Duquesne Light

Reference: Beaver Valley Power Station, Unit #2
Docket 50-412, License NPF-73
License Examination Report

FACILITY REVIEW OF WRITTEN EXAMINATION

NRC RESPONSE TO FACILITY COMMENTS

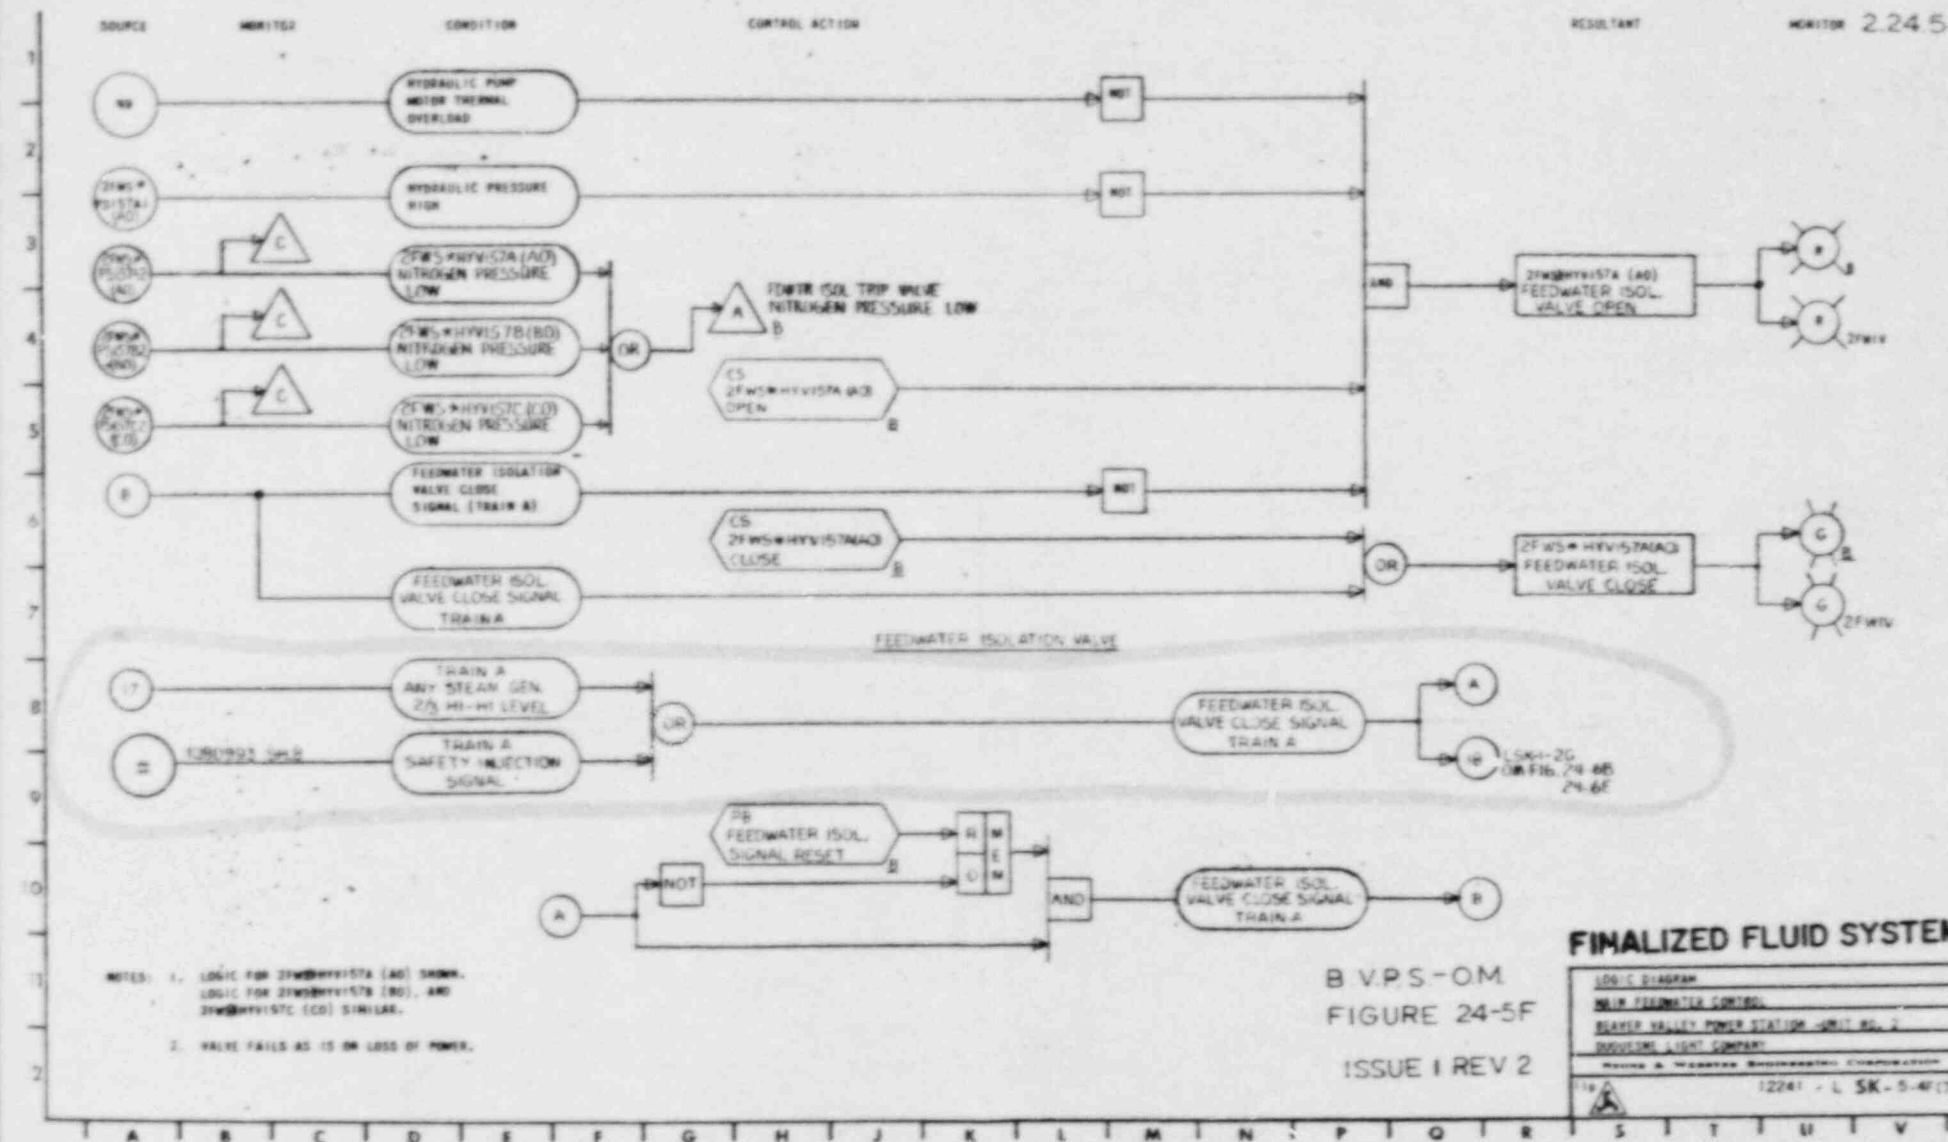
- 6.01a Accept answer that states a feedwater isolation comes from a safety injection or a hi-hi steam generator level. See attached logic diagram.

6.01.a Comment accepted.

question 705A

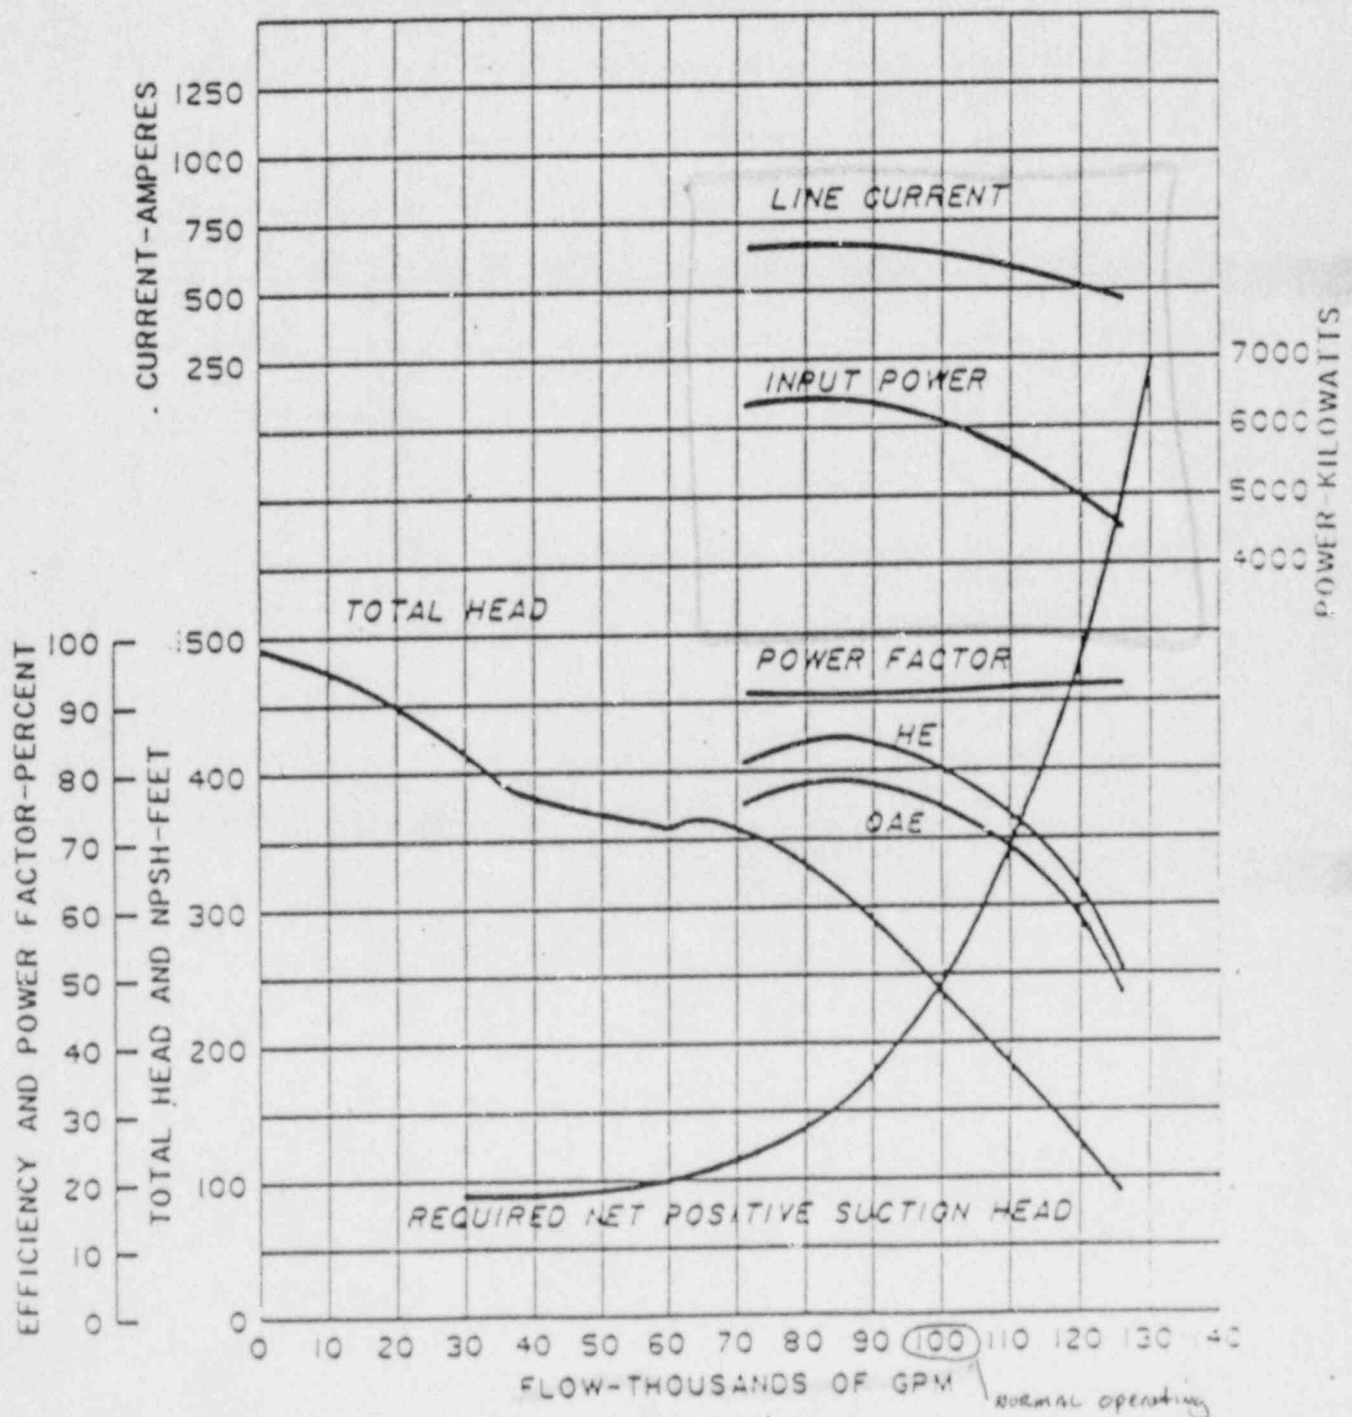
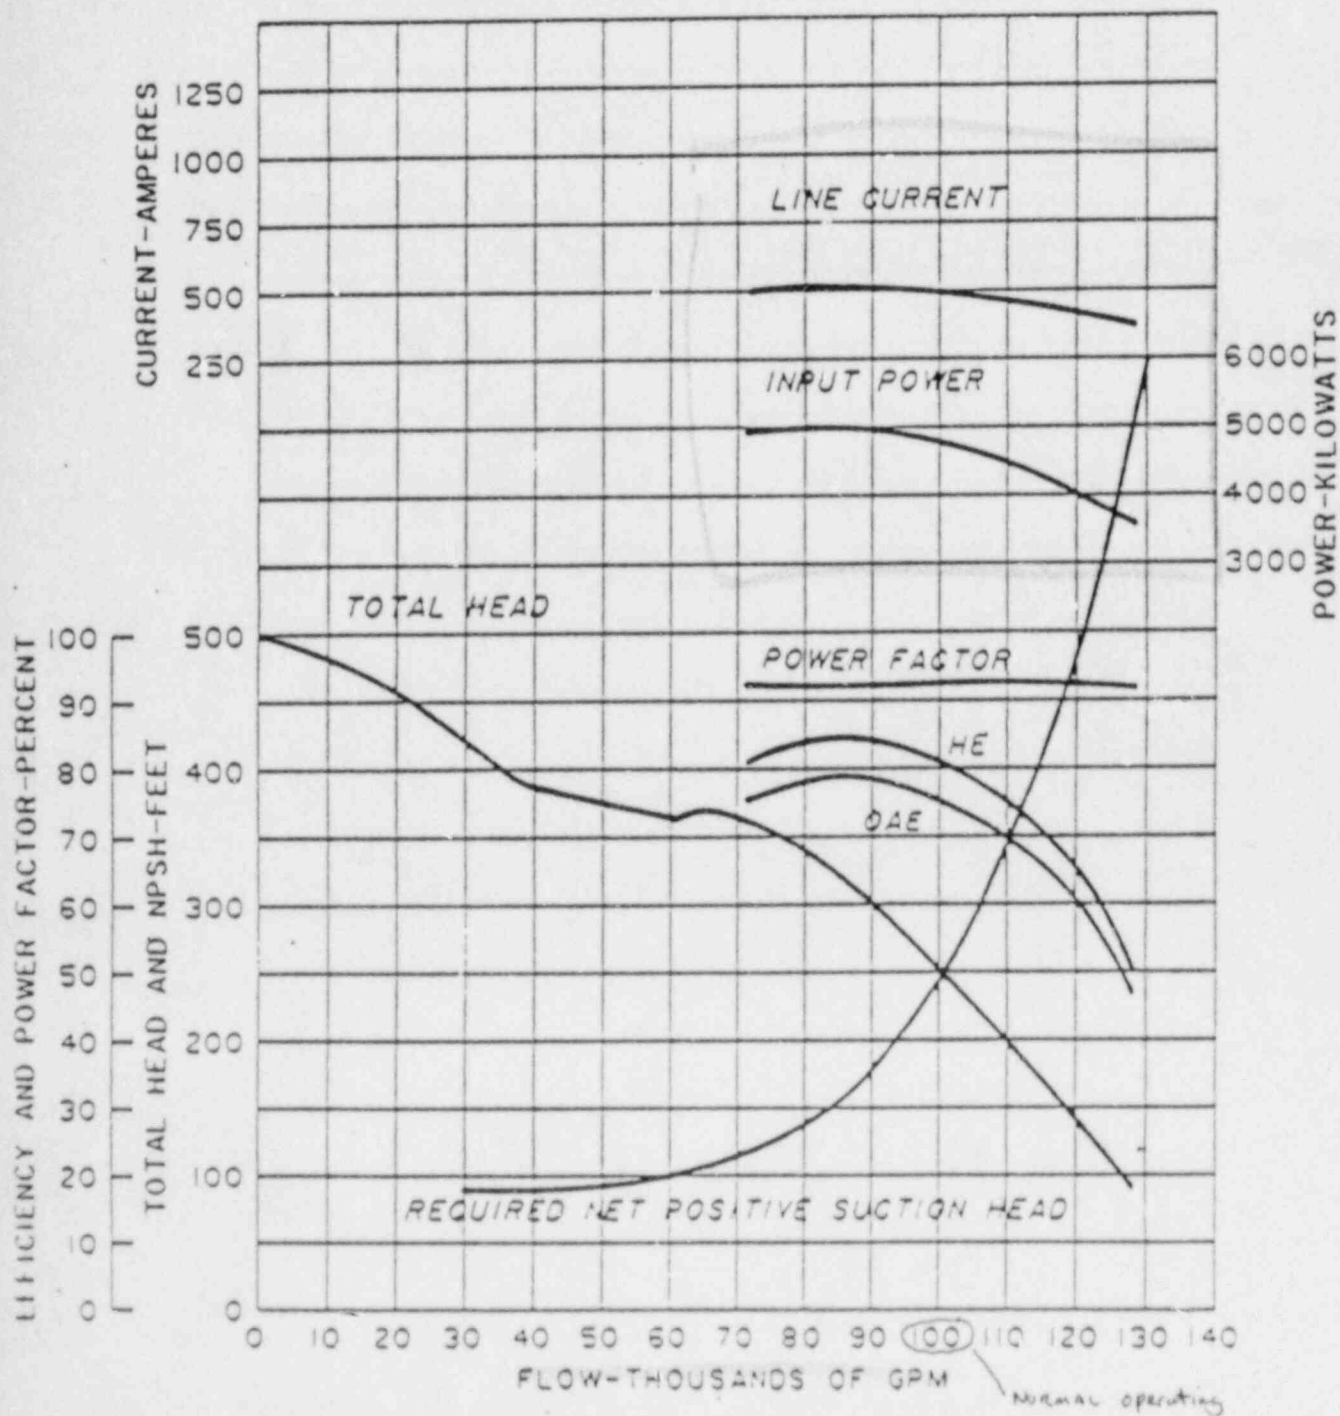
7.05.a At BVPS, RCP amps increase as flow starts to decrease in the RCS, so amps could initially increase as loop stop valve drifts shut. This should be an additional correct answer. See attached RCP performance curves.

7.05.a Comment accepted.

Question 7, 10 B

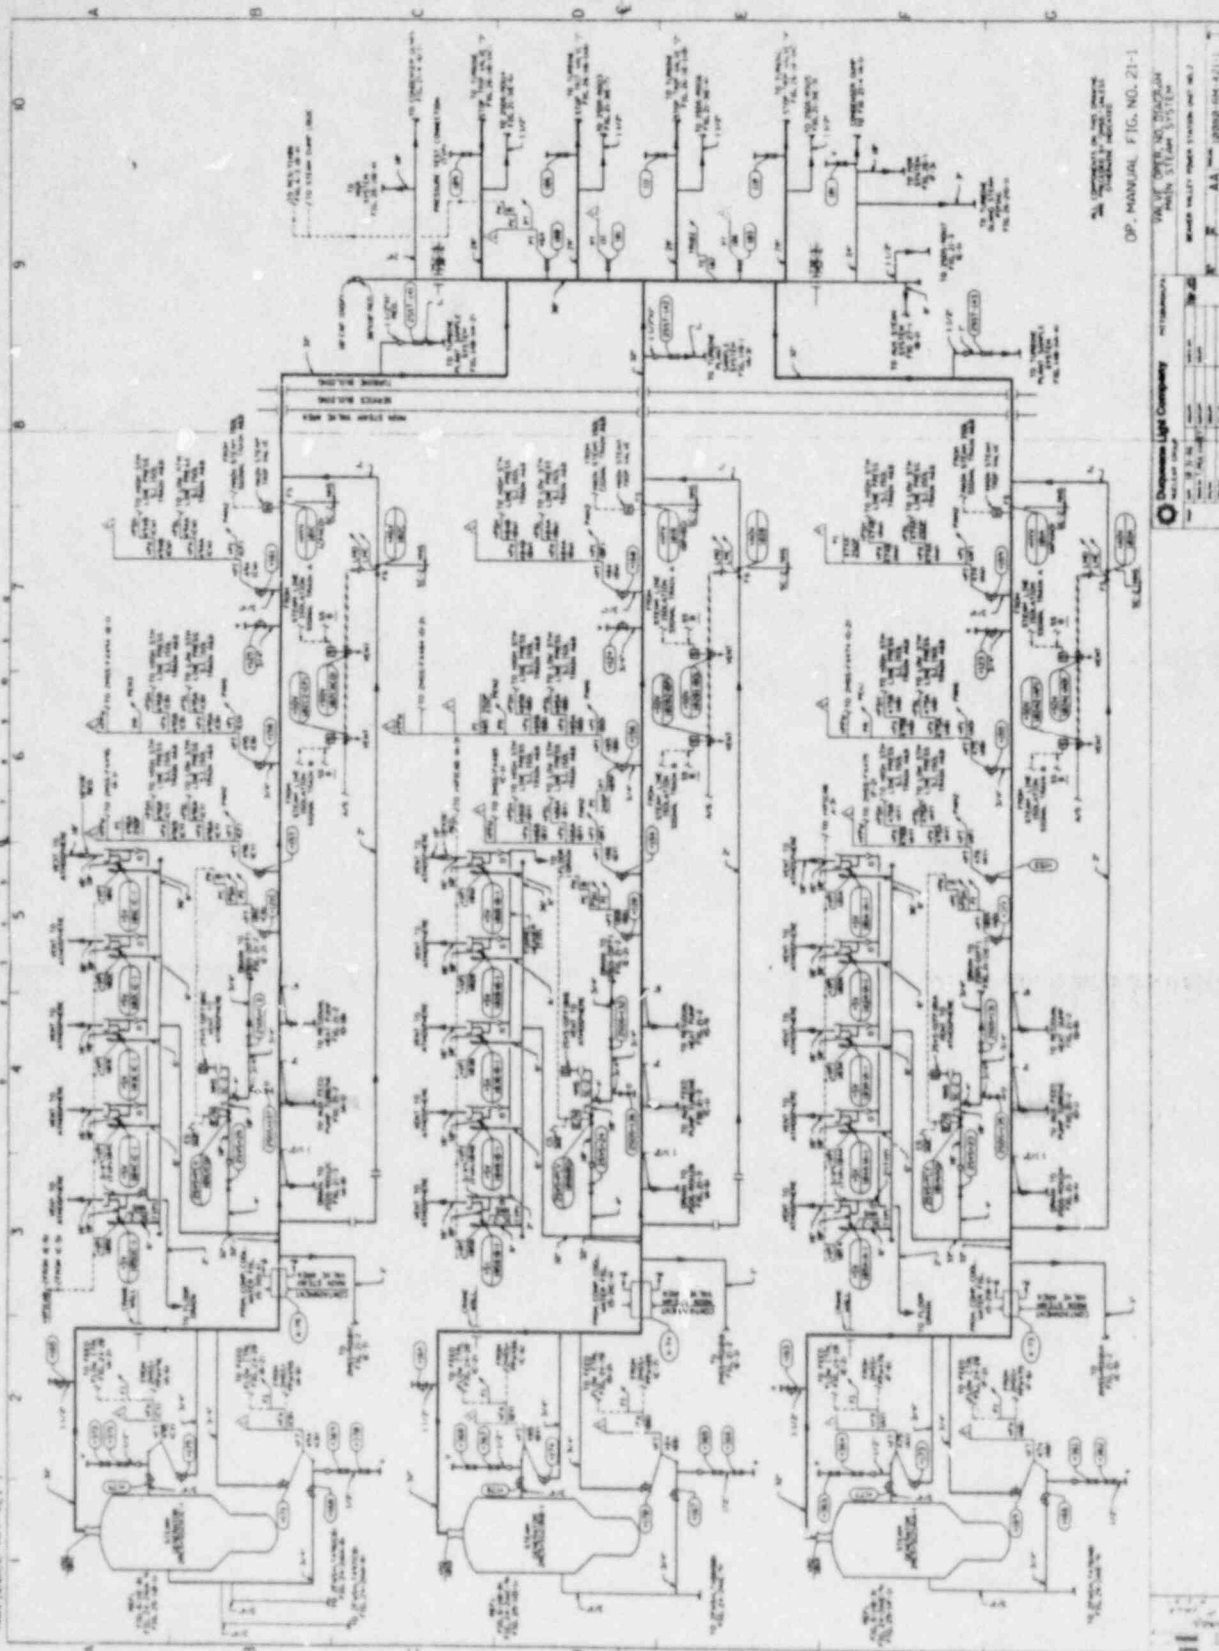
7.10.b The correct answer should be SG-A since it is neither faulted or ruptured (intact) and all three SG's can supply the turbine driven aux. feed pump. See attached.

7.10.b Comment accepted. The answer key was changed to, "S/G 21A [0.50] because it is neither faulted or ruptured [0.85]."
